Re: Proposed Vulcan Construction Materials Quarry, Quihi, Medina County, Texas—  
Proposed Water Pollution Abatement Plan (WPAP)  
EAPP ID: 2502.00, Investigation # 462519, RN104921630

**RE: Comments on the WPAP for the Vulcan Materials Medina Quarry**

**RE: Vulcan Materials Quarry, Medina County  
Water Pollution Abatement Plan (WPAP)**

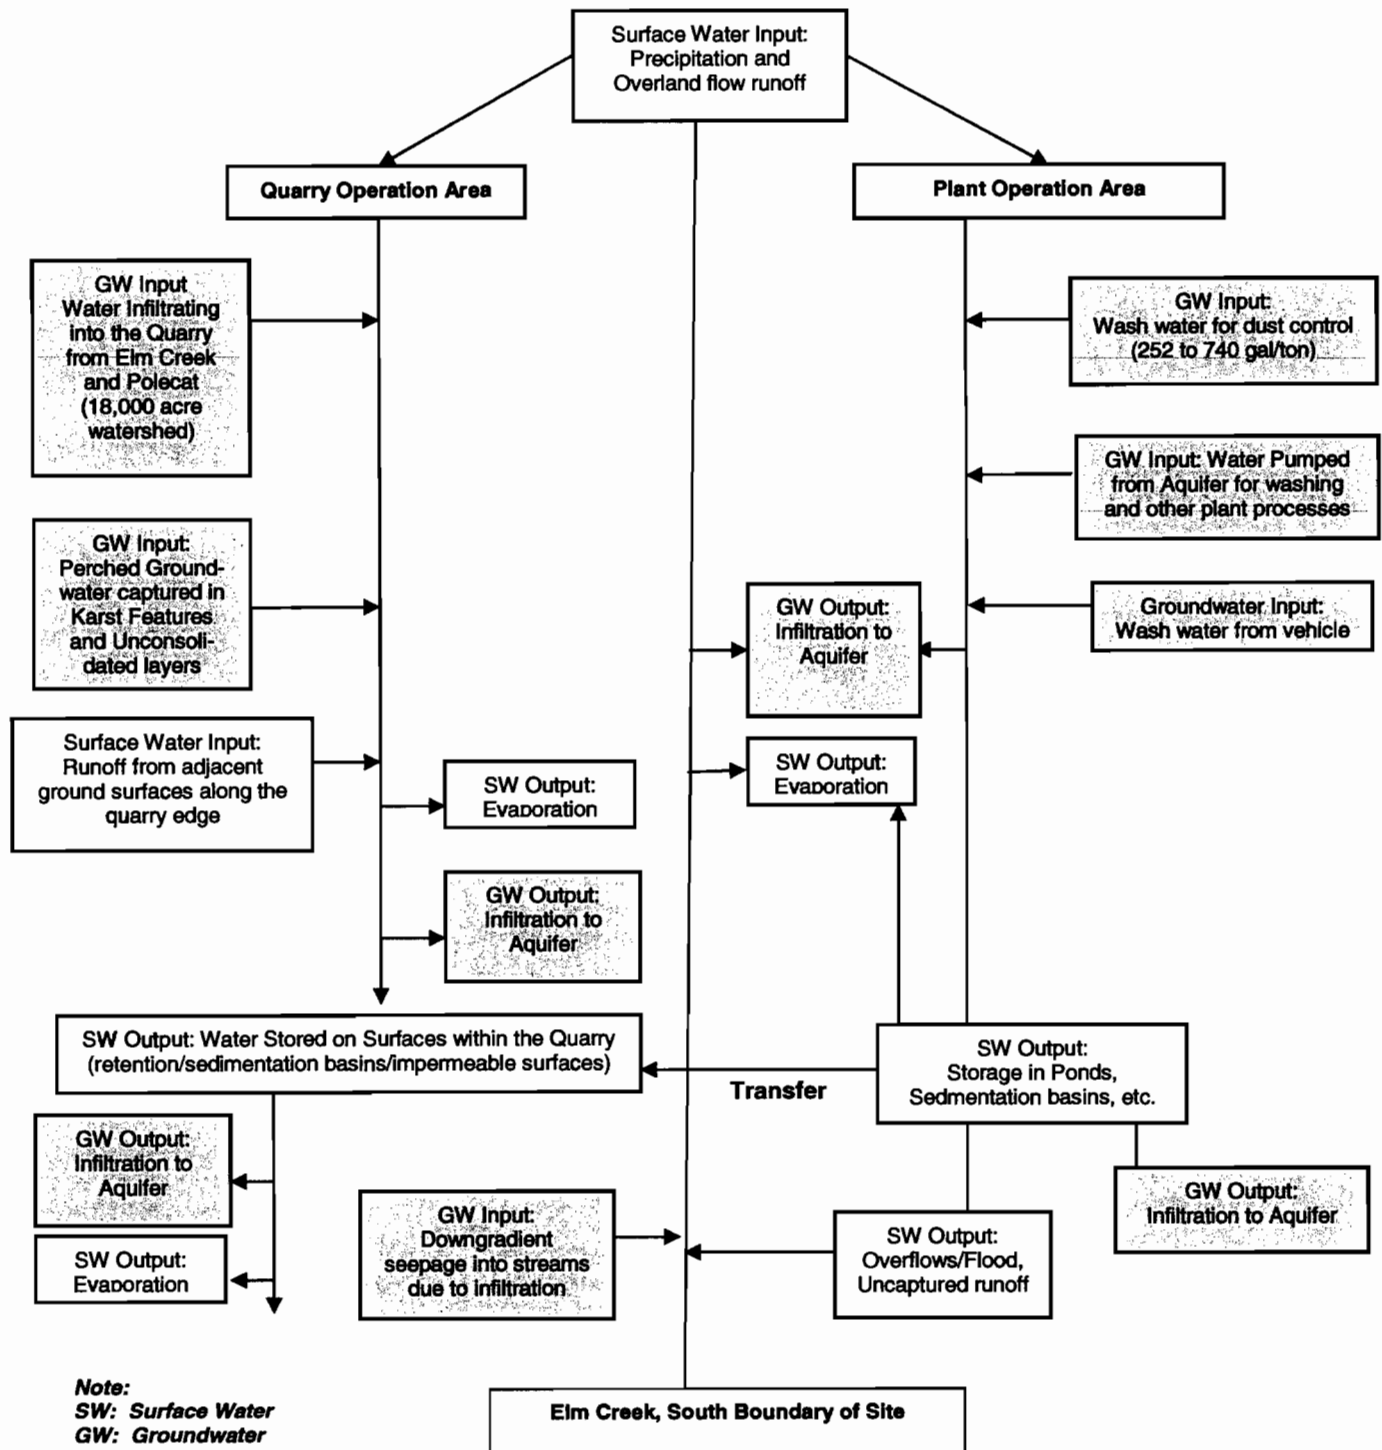
The WPAP indicates that only 37 acres of impermeable surfaces will be created by this project. The blasting process creates these fine particles that, according to Vulcan, are self-sealing. Those fine particles will fall all over the floor of the quarry and be compacted by equipment, causing the floor to be impermeable. If these particles are efficient as a retardant of potential pollutants into the aquifer in sedimentation basins, they would also act as a barrier of recharge water into formerly permeable portions of the recharge zone. If we accept the premise that those particles do indeed seal the ground surface, then the area of impermeable surfaces that are created by the project will be greater than 1000 acres. This is not addressed by the WPAP. Studies should be conducted to determine how this permanent loss of recharge water will affect surface and groundwater hydrology and the aquifer during the operation of the quarry and after the quarry has closed.

Finally, it is difficult to believe that even if the self-sealing process could take place within the required time frame, it would not be interrupted by the regular excavation of the sedimentation basins when they are reduced to 75% of original storage capacity (response to TCEQ Question 23B) or when the level of silt exceeds 6 inches (Permanent BMPs, original WPAP, TCEQ Form 0600 Attachment G.). It is not at all clear that the purported impermeability of the unlined sedimentation basins will be maintained while pursuing the WPAP's stated goal of sealing the quarry. Similarly, as noted above, if the assumption of impermeability in the sedimentation basins is justifiable, the assumption of impermeability when the fine particles are spread in the quarry requires further revisions to the hydrologic calculations.
